**GEORGIA POWER COMPANY
INSERVICE TEST PROGRAM**

**VOGTLE ELECTRIC GENERATING PLANT
UNIT 1**

ISI-P-008

Revision 8 Summary of Changes

PUMP INSERVICE TESTING LOOP FOR CENTRIFUGAL CHARGING PUMP 1-1208-P6-002

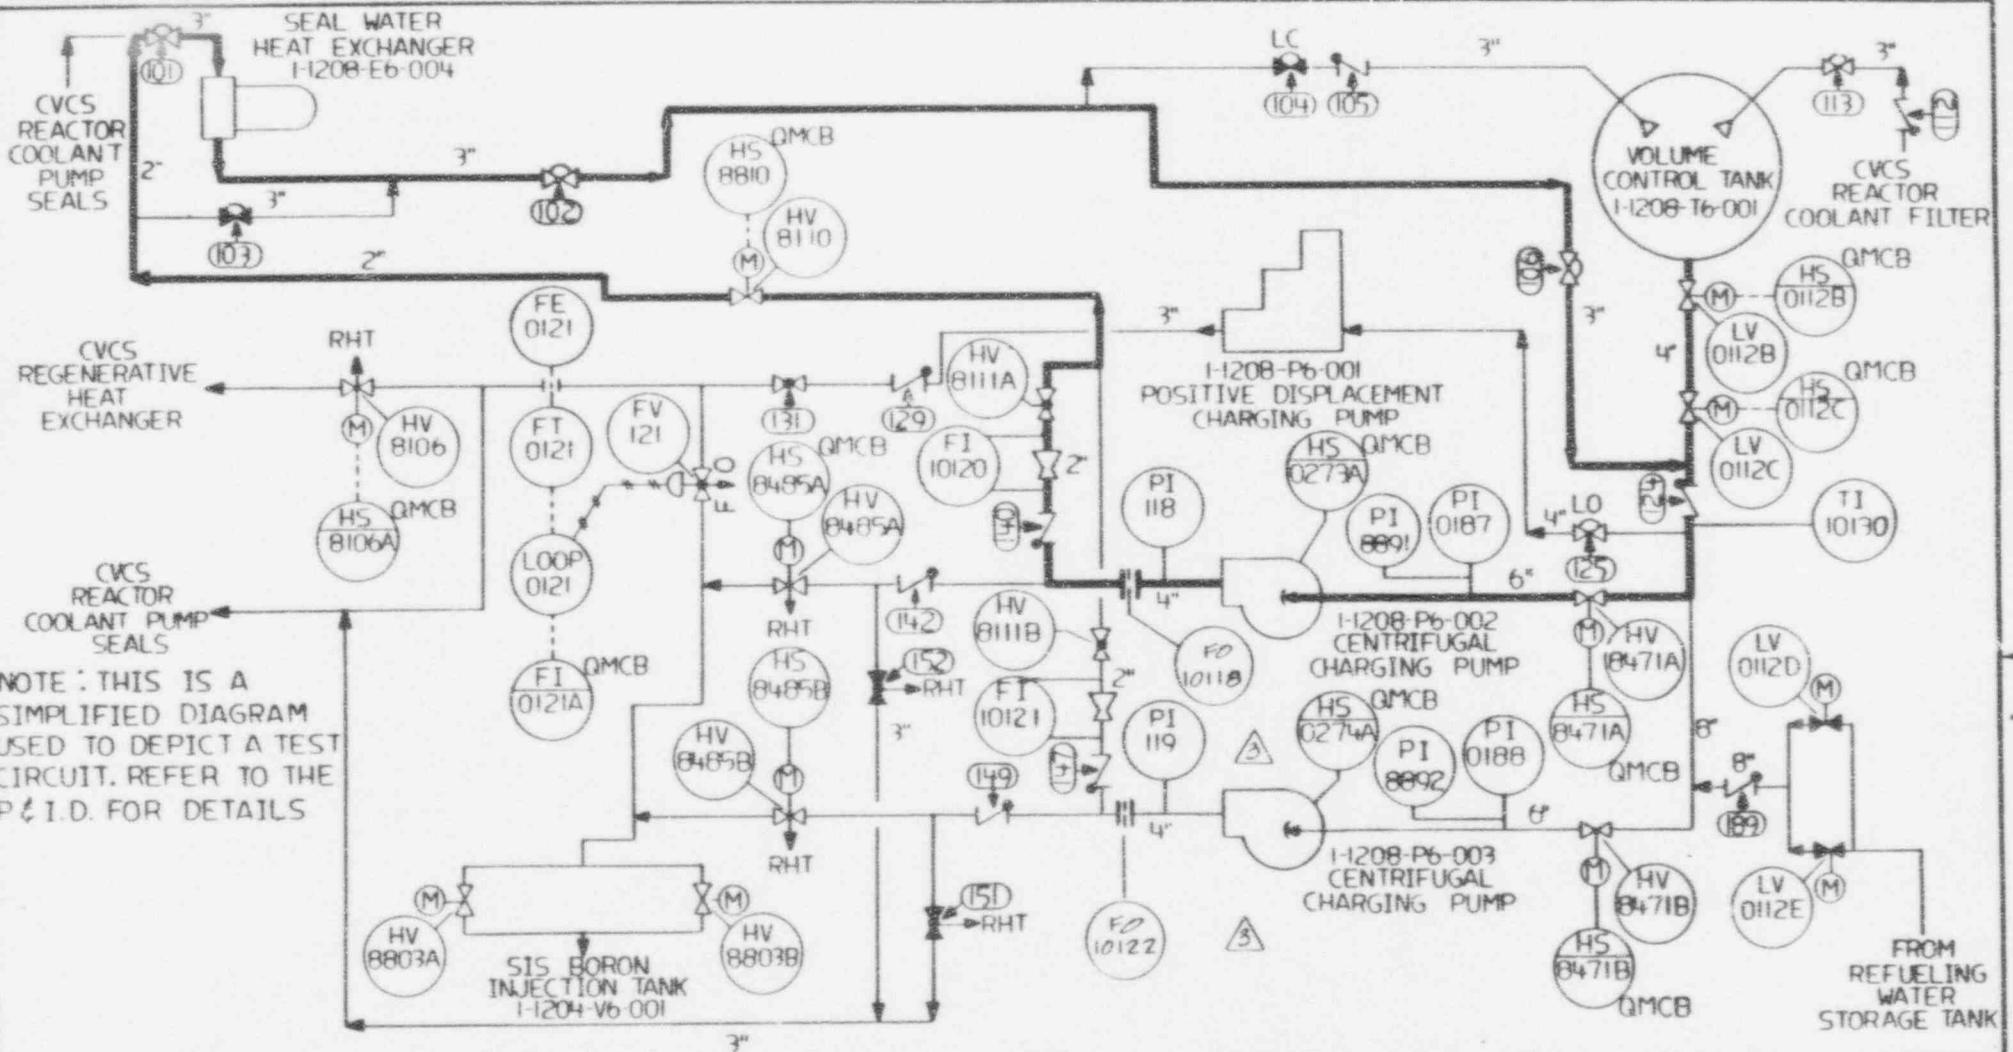
List of Effective Pages	Revised to indicate the current revision number of each page in the program document. See below for pages affected.
Drawings ISI-D-221 & ISI-D-222	Revised per PCR 93-008. (CVCS Section)
Figures 3f-1 and 3f2.	Revised per PCR 93-009. (CVCS Section)
Page 4-22	Revised Valve Test List to indicate a change in test frequency for valve HV8804B from quarterly to a cold shutdown frequency per PCR 93-023.
Page 4-23	The Valve Test List was revised to show RHR check valves 1-1205-U6-001 and 002 to be partially stroke exercised quarterly per PCR 93-013.
Page 6-35	Cold Shutdown Justification CS-35 withdrawn per PCR's 93-013 and 93-025.
Page 6-36	Cold Shutdown Justification CS-36 rewritten per PCR 93-013.
Page 6-41	Added Cold Shutdown Justification CS-41 to justify testing valve HV8804B at cold shutdown frequency per PCR 93-023.

REV.	DATE	BY	CHK'D	DESCRIPTION	APPR. 1	APPR. 2	APPR. 3	APPR. 4	APPR. 5	REMARKS
0	5-24-89	WJS	WJS	ISSUED FOR PST						
1	7-24-89	WJS	WJS	UPDATED TO 1X4DB116-2 REV.10						
2	10-18-88	WJS	WJS	ADDED PI 8891, 8892						
3	12-19-91	WJS	DRG	ADDED FO 1011B AND FO 10122.

PUMP INSERVICE TESTING LOOP FOR CENTRIFUGAL CHARGING PUMP 1-1208-P6-003

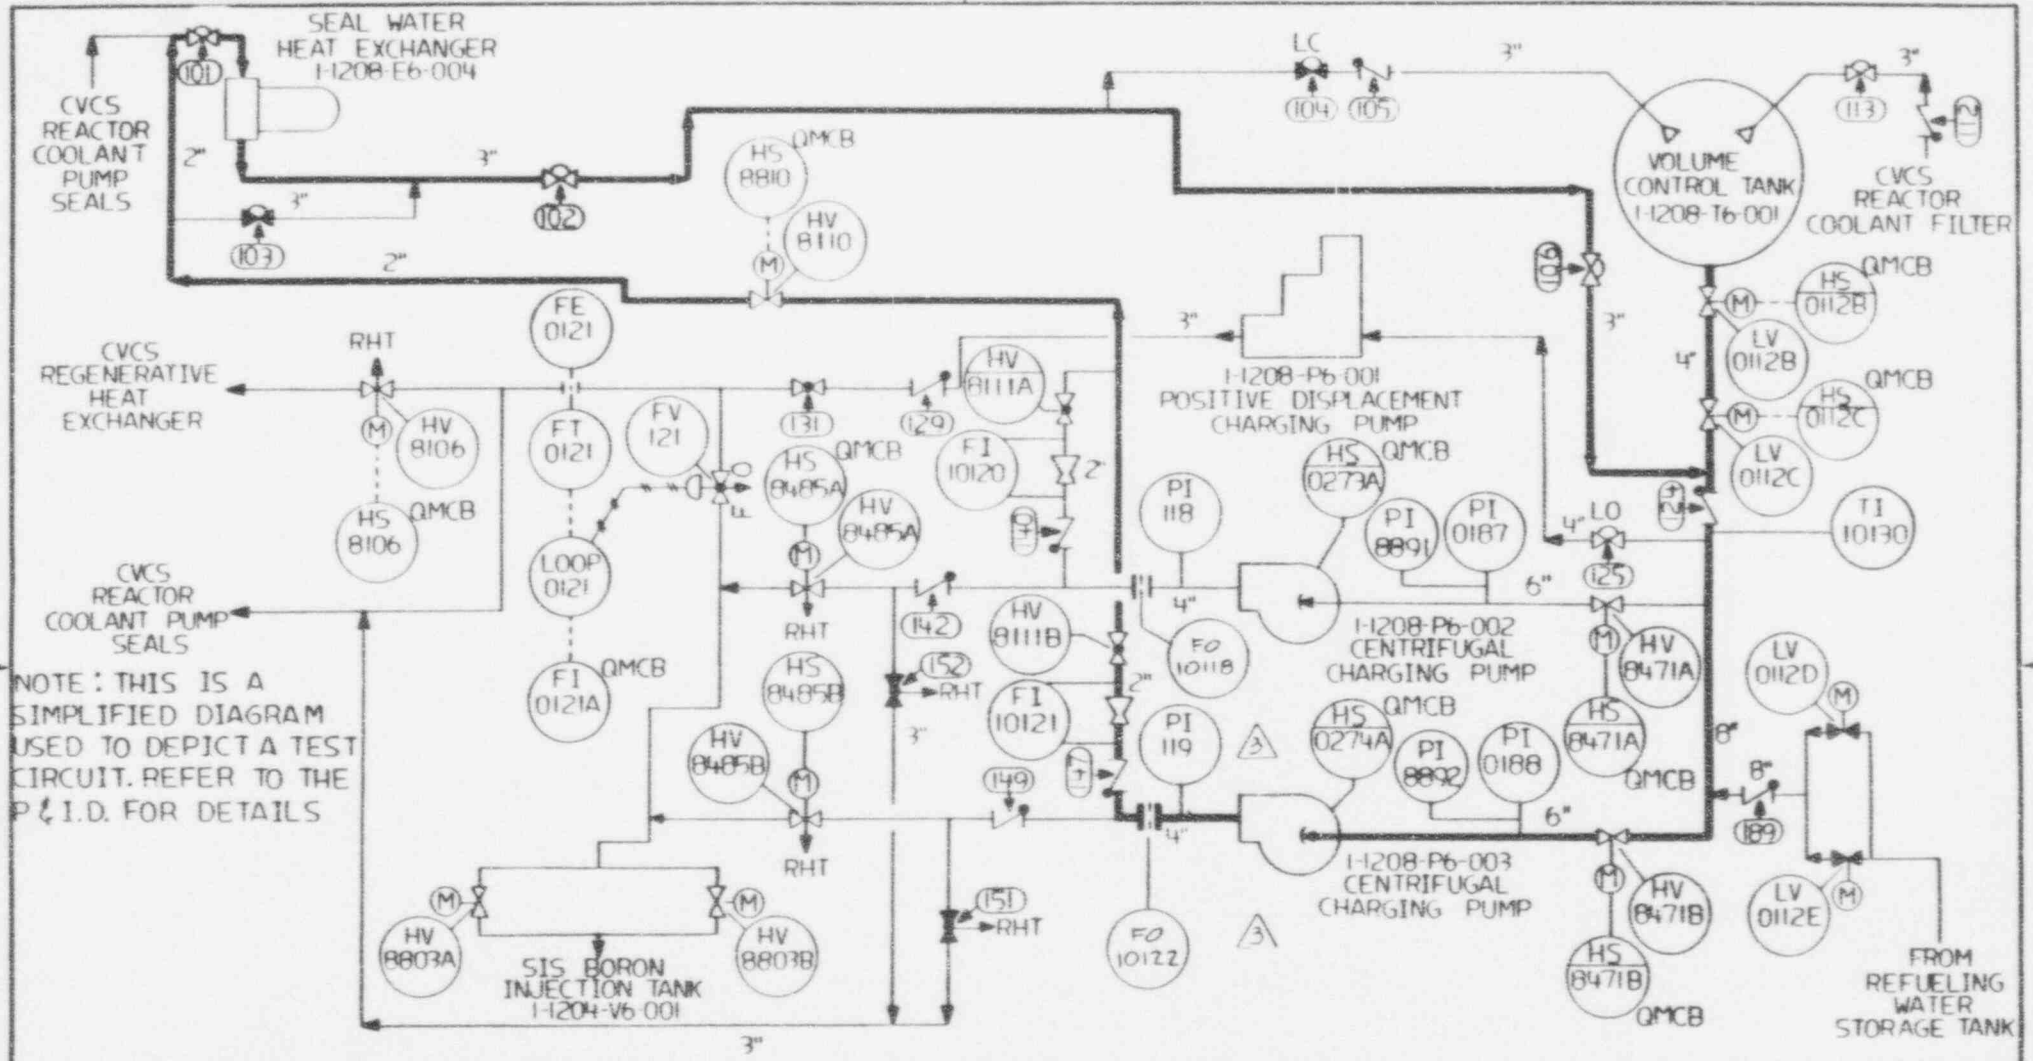
REV.	DATE	BY	CHK'D	DESCRIPTION	APPR. 1	APPR. 2	APPR. 3	APPR. 4	APPR. 5	REMARKS
0	5-20-84	WS	WS	ISSUED FOR PST						
1	7-24-86	WS	WS	UPDATED TO IS4DB116-2 REV. 10						
2	6-18-88	WS	WS	ADDED PI 8891, 8892						
3	12-16-93	WS	WS	ADDED FO-1011B AND FO-1012Z
